UNITED STATES
NUCLEAR REGULATORY COMMISSION
WASHINGTON, D.C. 20555-0001

SUBJECT: OCONEE NUCLEAR STATION, UNITS 1, 2, AND 3 - ISSUANCE OF
AMENDMENT NOS. 420, 422, AND 421 RE: MEASUREMENT UNCERTAINTY
RECAPTURE POWER UPRATE (EPID L-2020-LLS-0000)

Amendment No. 420
Renewed License No. DPR-38

The licensee proposed to revise the RFOLs and TSs to implement a measurement uncertainty recapture power uprate (MUR-PU) that would increase the maximum licensed rated thermal power (RTP) from 2568 megawatts thermal (MWt) to 2610 MWt, which is an increase of 42 MWt, approximately 1.64 percent.

Figure 3.4.3-1 (page 1 of 1)
RCS Normal Operational Heatup Limitations
Applicable for the First 44.6 EFPY - Oconee Nuclear Station Unit 1

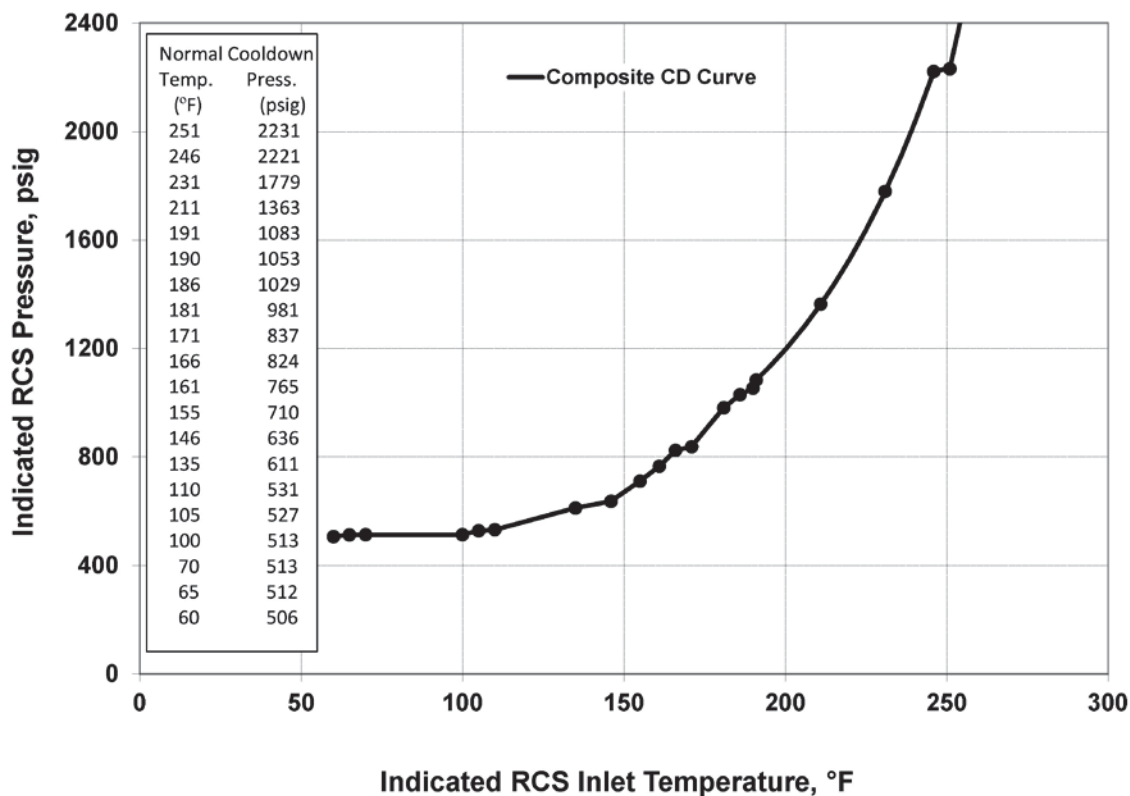
The licensee proposed to revise the applicability of the RCS heatup curves in TS Figures 3.4.3-1 through 3.4.3-9 to reflect updated EFPY limitations. The limits are based on revised reactor vessel material evaluations. The Unit 1 applicability would be changed from the first 54 EFPY to the first 44.6 EFPY; the Unit 2 applicability would be changed from the first 54 EFPY to the first 45.3 EFPY; and the Unit 3 applicability would be changed from the first 54 EFPY to the first 43.8 EFPY.
